HEARTLAND ACRES ADDITION SEDGWICK COUNTY, KANSAS

RE: S/D 97-89 - One-Step Final Plat of HEARTLAND ACRES ADDITION

STAFF REPORT

CASE NUMBER: S/D 97-89 - HEARTLAND ACRES ADDITION

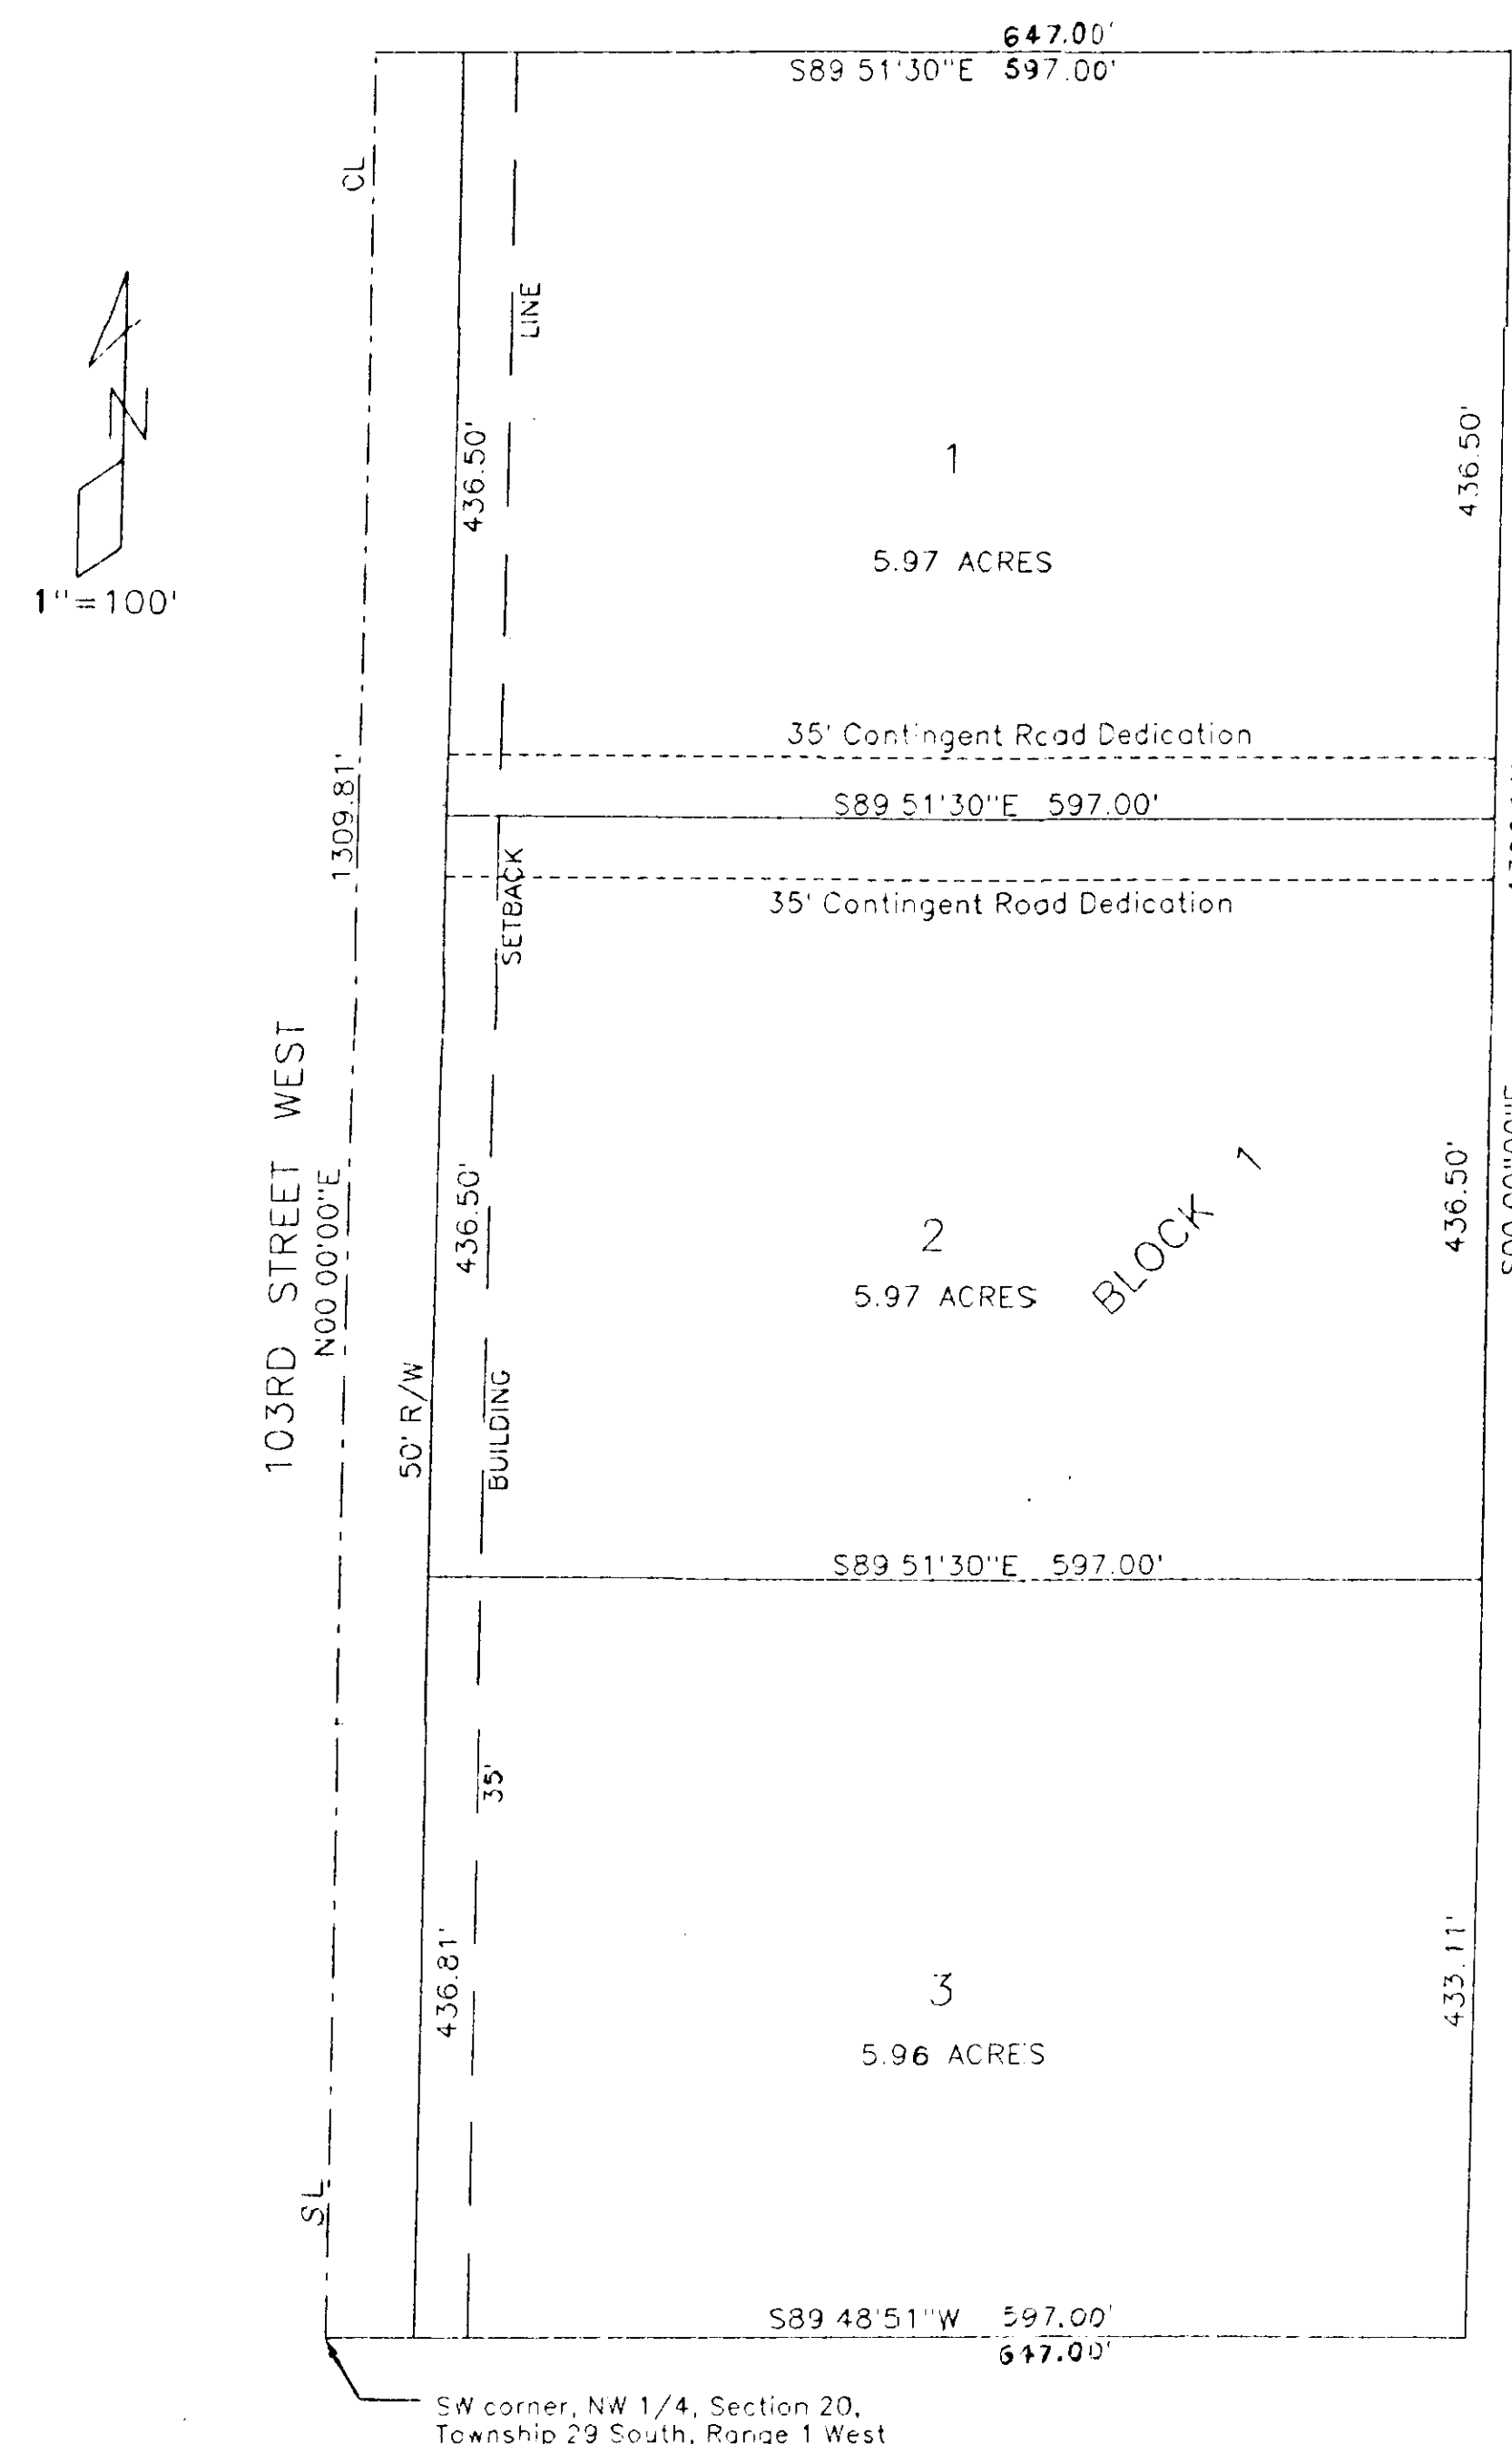
- C. The Wichita-Sedgwick County Comprehensive Plan specifies that low-density residential lots are to be separated from section line roads. Therefore, the plat should denote the contingent dedication of a 70-foot street right-of-way between either lots 1 and 2 or between lots 2 and 3 extending to the eastern line of the property. A joint access should also be located between two of the lots. County Engineering has requested a 70-foot contingent dedication of right-of-way at the southern line of the plat (between the two quarter sections) along with a temporary right-of-way at the terminus for a turnaround. Each lot shall be restricted to one point of access.

- D. County Engineering needs to comment on the status of the applicant's drainage plan. The drainage plan has been approved. The language on the plat regarding the dedication of contingent right-of-way needs to be revised.

- E. The legal description in the platting binder does not correspond with the land being platted. Also, the distances for the perimeter of the property along the eastern and western property lines should be denoted on the face of the plat.

- F. The Zoning regulations require an 85-foot setback from the centerline of section line roads. The 30-foot front yard setback denoted on the plat needs to be increased to 35 feet. Also, the centerline of 103rd Street West should be labeled "CL".

The South 35 feet of Lot 1 and the North 35 feet of Lot 2 as shown by dashed lines is hereby contingently dedicated as street right-of-way, to become effective upon the platting of any adjacent subdivision having a street connecting thereto. The costs of constructing said street are to be borne solely by the person(s) or agency that owns said adjacent subdivision.

The contingencies herein created are hereby granted to the appropriate governing body then having jurisdiction over said connecting streets, to be exercised solely within said body's discretion and without further authority from the fee owner.

ALL ADJUTERS RIGHTS OF ACCESS TO 103RD STREET WEST OVER AND ACROSS THE WEST ROW LINE ARE HEREBY DEDICATED TO THE APPROPRIATE GOVERNING BODY, PROVIDED HOWEVER, THAT LOTS 1, 2, AND 3, BLOCK 1 SHALL HAVE ONE ACCESS OPENING.
